EAGLE TECHNICAL BULLETIN

Eagle Technical Bulletin Number: TB-E407-789-15

Purpose: To allow the optional start switch upgrade.

This Technical Bulletin provides installation information for the 407HP installation as it applies to Bell 407 aircraft with Aeronautical Accessories Inc. Pulse Light Kit installed per STC SR09239RC.

FIGURE 1: START SWITCH UPGRADE COMPONENTS INSTALLATION

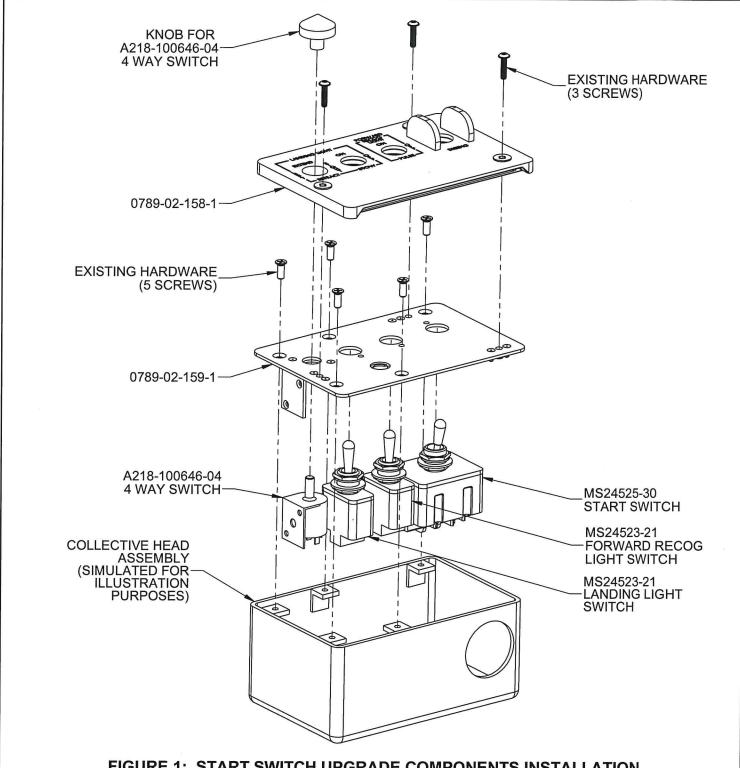
- 3. Disconnect electrical connections from the Start Switch only and remove the switch.
- 4. Install P/N MS24525-30 Start Switch on the 0789-02-159-1 Switch Plate Assembly per Figure 1.

- 5. Install the previously removed (in step 2) 4 Way Switch, Landing Light Switch and Forward Recog Light Switch on the 0789-02-159-1 Switch Plate Assembly per Figure 1.

- 6. Connect wiring to Start Switch per IIN-E407-789 and wiring diagram 0789-14-001.
- 7. Install 0789-02-159-1 Switch Plate Assembly with Switches installed on the collective head using existing hardware per Figure 1.

- 8. Install 0789-02-158-1 Display Panel Assembly on the collective head using existing hardware per Figure 1.
- 9. Make entry into aircraft technical reports to indicate TB-E407-789-15 has been completed.
